Enclosed, please find copy of SPECIAL MAINTENANCE INSTRUCTION No. RDSO/2010/EL/SMI/0264 (Rev. '0') Dated: 15.07.2010 Use and Maintenance/Fitment Practices of Equalizer & Compensating Beam Pins, Bushes & Cotters in WAG7 Locomotives, along with drawings SKEL- 4777 (Alt '0') dated June 2010 and SKVL-703 (Alt '0') dated June 2010.

SPECIAL MAINTENANCE INSTRUCTION No. RDSO/2010/EL/SMI/0264 (Rev. '0') Dated: 15.07.2010

Use and Maintenance/Fitment Practices of Equalizer & Compensating Beam Pins, Bushes & Cotters in WAG7 Locomotives.

^{RG.} SK.VL.−703

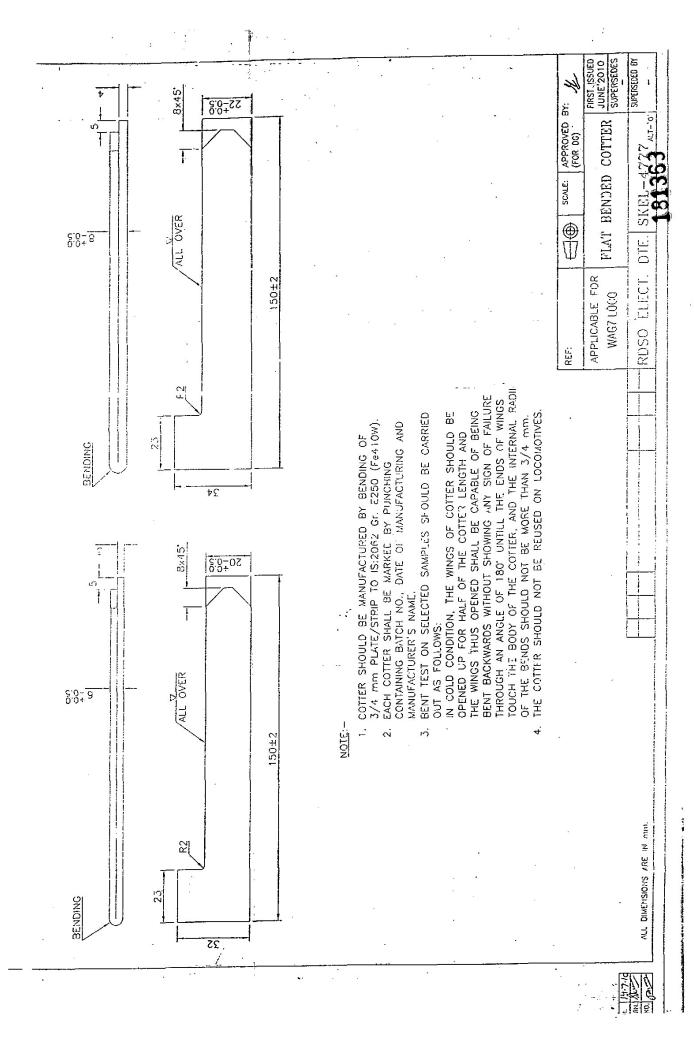
- Use of proper design cotters.
- 3.2 Considering the above, the existing drawing of MP Dte/RDSO No. SKVL-139 is revised as SKVL-703 (Alt '0') dated June 2010 for WAG-7 efectric locomotives. The drawings & specification of cotter, adjusting steel washers, splitting of cotter after fitment is included in the same drawing. This drawing should be used for procurement of pins, cotters, steel washers & bushes. The earlier issued all the drawings, instructions should be treated as superseded. Besides, there are other maintenance requirements for reliable and safe working of the suspension arrangement. Railways should implement the modified instructions as given below:-

- 4.12 The use of steel spacer/washer of required sizes should be used as shown in the drawing. If required the step size washer of 1/2/3mm should be used for tight fitment of cotter.

- 4.13 The fitment arrangement of pins will be such that the cotter end (tail end) will be in front and head will be in rear to facilitate easy inspection of cotters. However, the axle box pin (longer size pin) shall be fitted with head in front for easy changing of the pin.

COTTER SHOULD BE MANUFACTURED BY BENDING OF PLATE TO iS:2062 Gr. E250 (Fe410W)

THE COTTER SHOULD NOT BE REUSED ON LOCOMOTIVES. BENT TEST ON SELECTED SAMPLES SHOULD BE CARRIED OUT AS FOLLOWS:

IN COLD CONDITION, THE WINGS OF COTTER SHOULD BE OPENED UP FOR HALF OF THE COTTER LENGTH AND THE WINGS THUS OPENED SHALL BE CAPABLE OF BEING BENT BACKWARDS WITHOUT SHOWING ANY SIGN OF FAILURE THROUGH AN ANGLE OF 190" UNTILL THE ENDS OF WINGS TOUCH THE BODY OF THE COTTER, AND THE INTERNAL RADII TOF THE BENDS SHOULD NOT BE MORE THAN 5 mm.

SEF SLACK APPEARS BETWEEN WASHER AND COTTER, STEP SIZE WASHERS (ITEM 9) OF 1/2/3 mm THICKNESS MAY BE USED.
